Addendum No. 1 December 3, 2025

City Project No. 23-068 Package 2 Roads Program Capital Improvement Project

This addendum includes revisions to Plans and Specifications and provides clarifications and answers to questions submitted to the City.

NOTE: If bidder is a corporation, the legal name of the corporation shall be set forth above together with the signature of the officers authorized to sign contracts on behalf of the corporation; if bidder is a

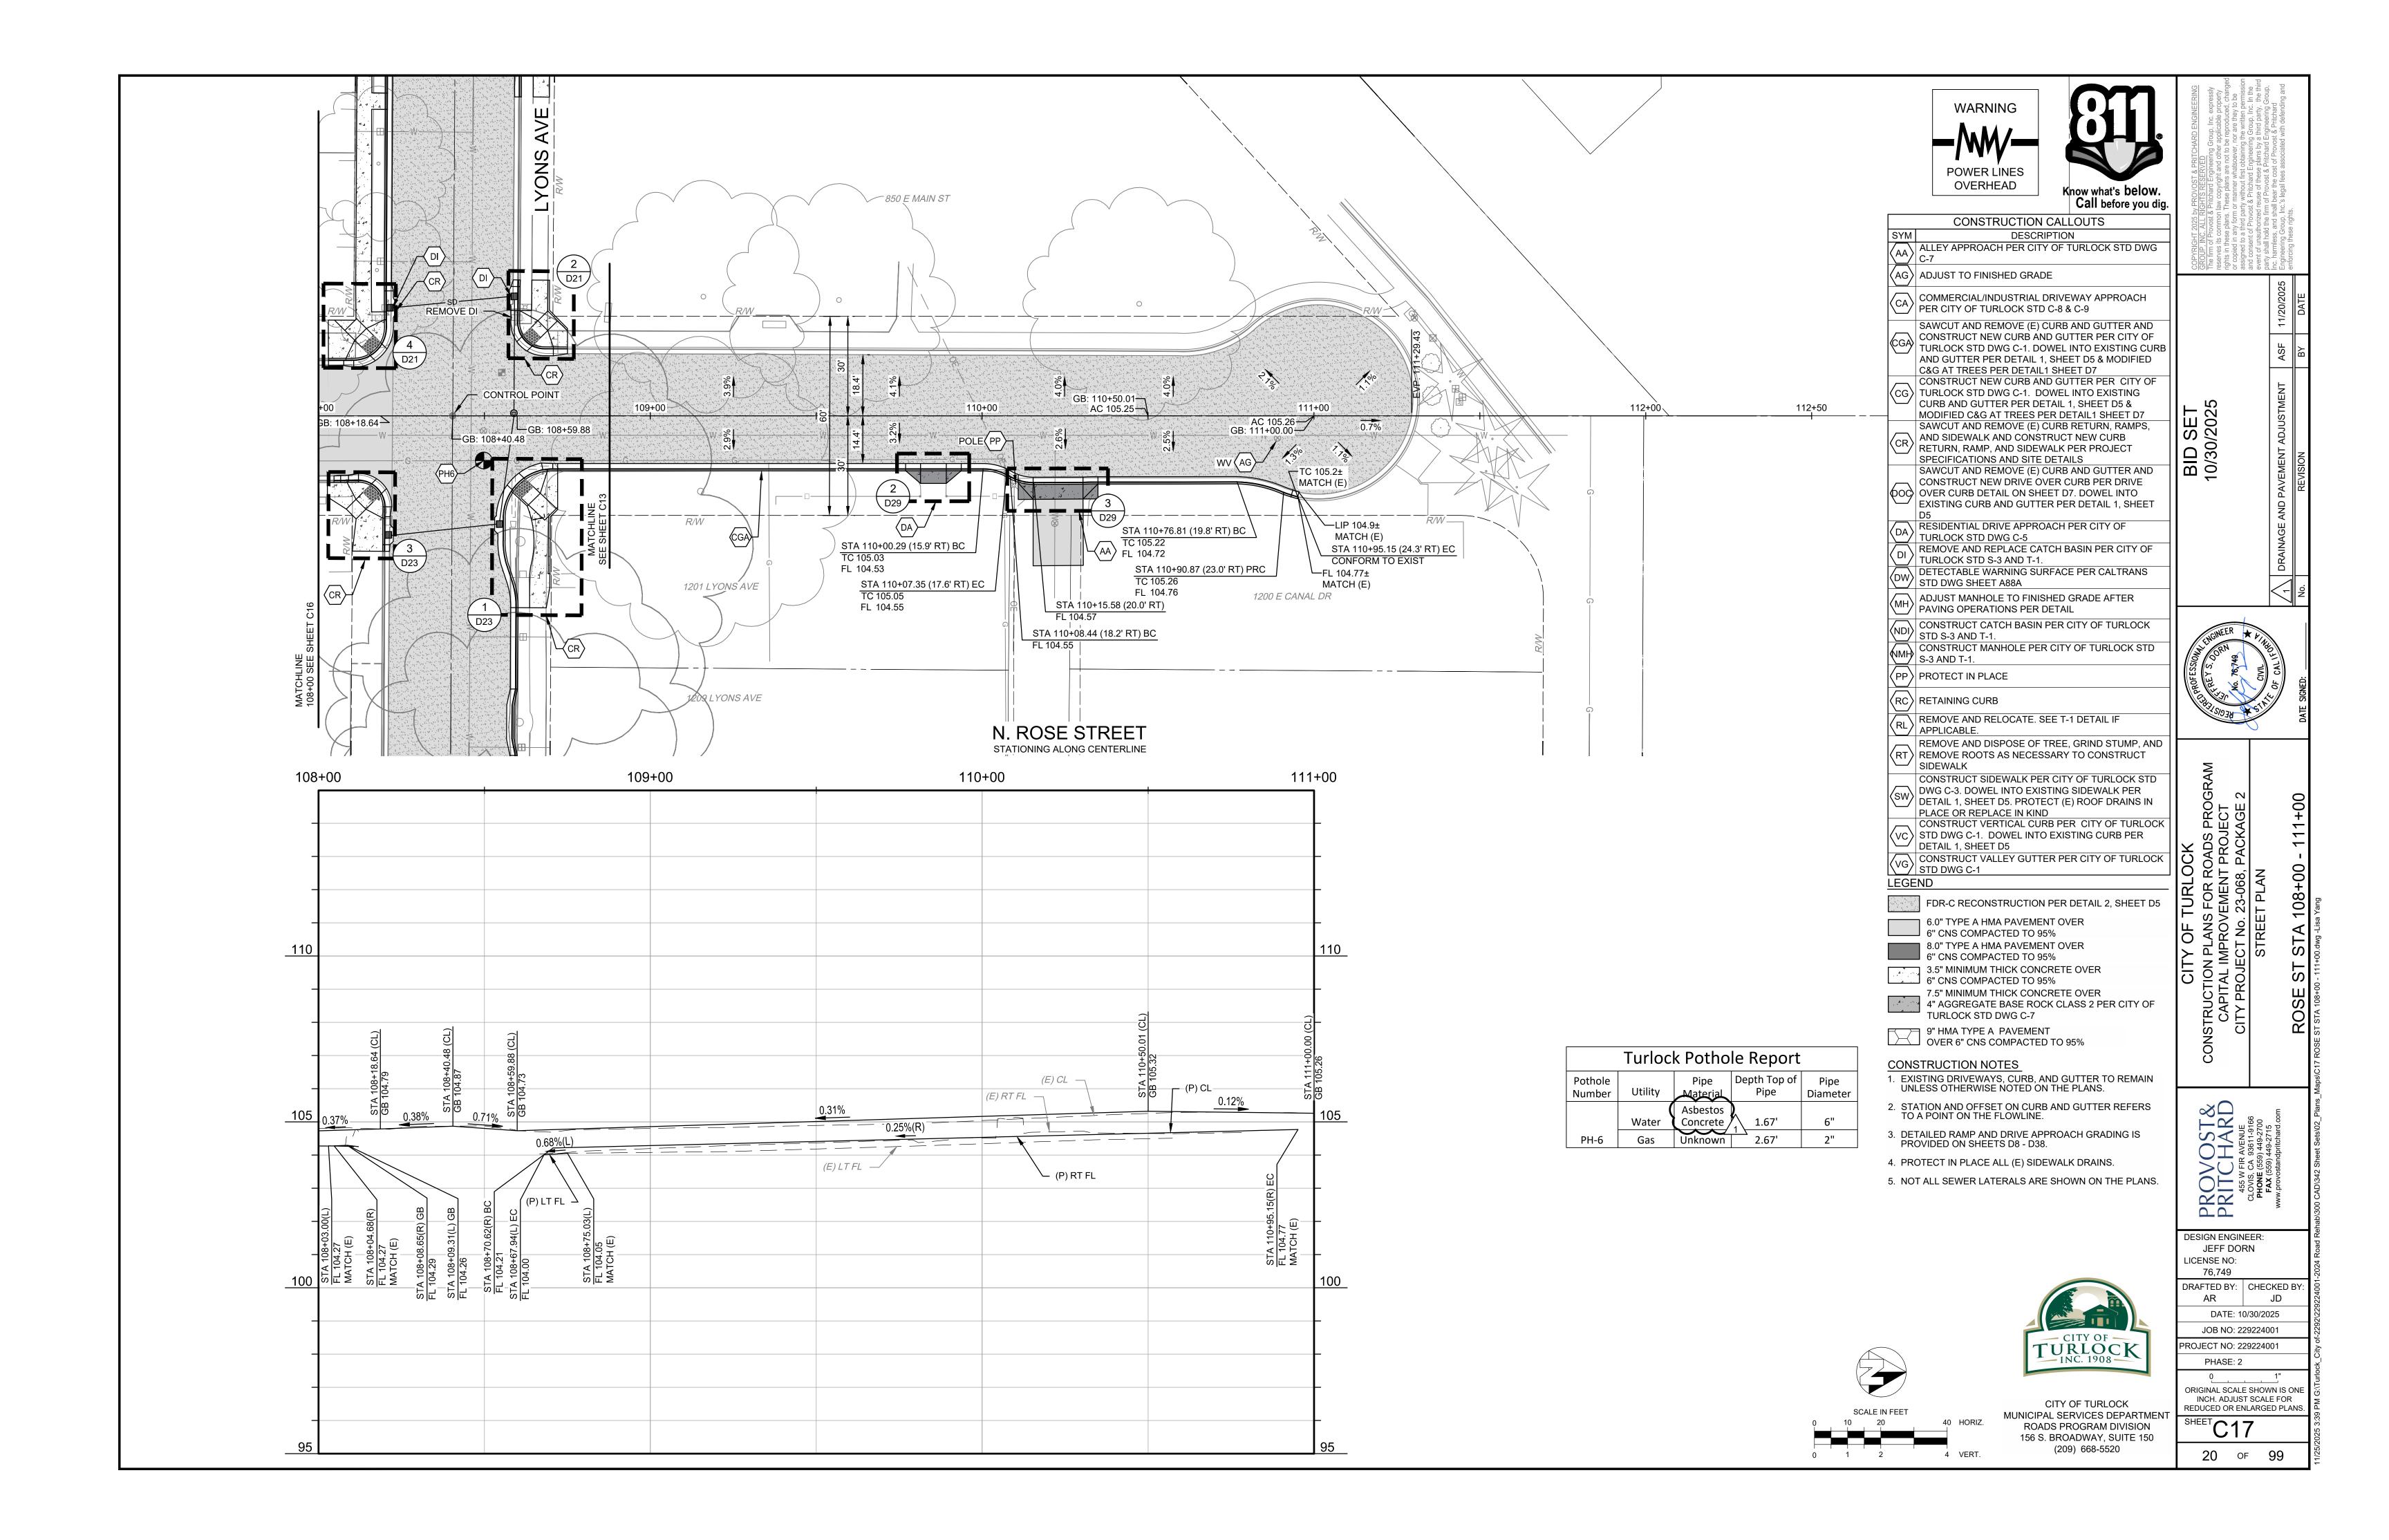
Delete sheets C1-C3 and replace with attached sheets C1-C3 of this addendum. Revisions consist of changing the street rehabilitation method and pothole report table.
